Number: #77  
Date: 9-12-74

## Service Information

Ride: YO YO                      Subject: GUSSET PLATE ADDITION  
SERIAL NUMBERS: 74-3300 THRU 74-3316, 74-3318

King Pin Section of Trailer

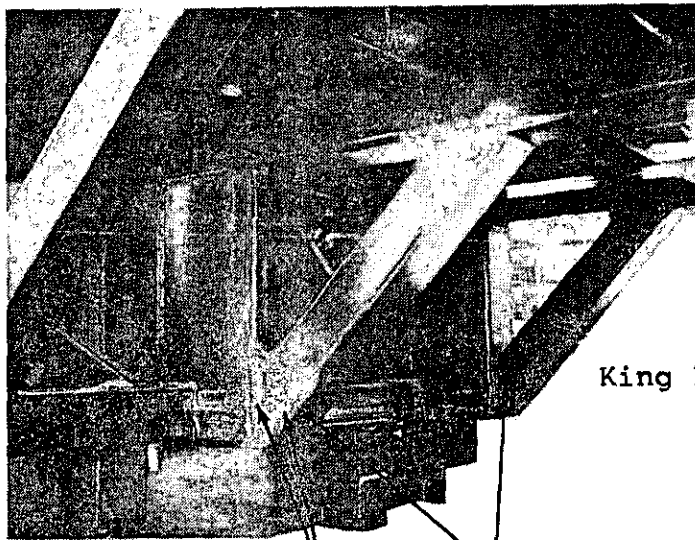
Because of a combination of factors, among them rough road conditions, one area of the YO YO trailer is receiving a higher degree of stress than was expected. This has resulted in the partial failure of the weld joints.

As soon as we receive the enclosed card from you, we will ship eight gusset plates which should be added to the trailer as shown.

It is important that these gusset plates be added even though your trailer presently shows no signs of fatiguing.

3/8 inch Fillet Weld-two sides-  
E70XX Rod

Weld gusset plates on both  
side of tube
